# UNITED STATES PATENT AND TRADEMARK OFFICE

APPLICATION NO.	FILING DATE	FIRST NAMED INVENTOR	ATTORNEY DOCKET NO.	CONFIRMATION NO.
10/087,731	03/05/2002	Nobusige Arai	2936-0151P	1577
2292	7590	09/10/2004	EXAMINER	
BIRCH STEWART KOLASCH & BIRCH			STINSON, FRANKIE L	
PO BOX 747			ART UNIT	
FALLS CHURCH, VA 22040-0747			PAPER NUMBER

<b>Office Action Summary</b>	<b>Application No.</b>	<b>Applicant(s)</b>	
	10/087,731	ARAI ET AL.	
	<b>Examiner</b>	<b>Art Unit</b>	
	FRANKIE L. STINSON	1746

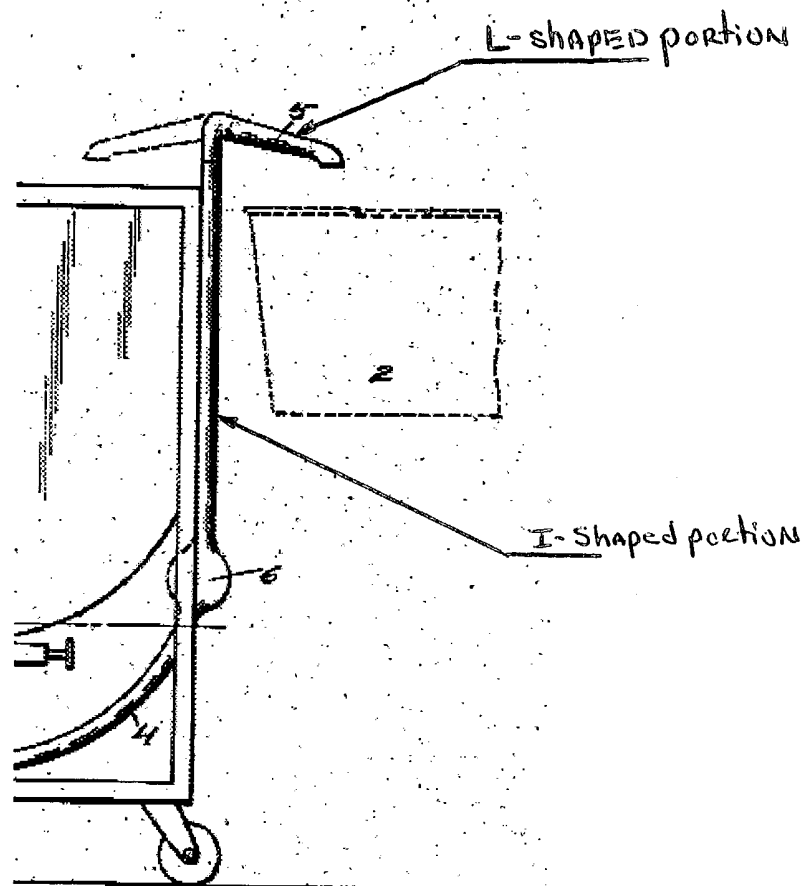
Re claim 1, Culver is cited disclosing a washing machine having a spout/nozzle fitted to the washing machine by a first and second portion so as to be movable between an in-use position and a non-use position different from the in-use position when not in use that differs from the claim only in the recitation of the partial washing apparatus fitted to the machine by a first and second portion coupled by a ball member. Japan'793 is cited disclosing in a washing machine a partial washing apparatus washing dirt from articles by means of supersonic vibrations. Therefore, given the teachings of Japan'793, it would have been obvious to one having ordinary skill in the art to modify the spout of Culver to be a partial washing apparatus for removing dirt by supersonic vibrations as taught by Japan'793, for the purpose of pre-treating particularly soiled portions of (laundry) articles. As for the first portion and second portion being coupled by a ball member to place the partial washing apparatus in an in-use position and a not-in-use

position, please note the use of a ball member is deemed to be a functional equivalent of the swivel joint in Culver (see MPEP 211.06, "SUBSTITUTING EQUIVALENTS KNOWN FOR THE SAME PURPOSE"). Re claim 52, Culver discloses the substantially L-shaped and I-shaped portions (see notations in the figure above).
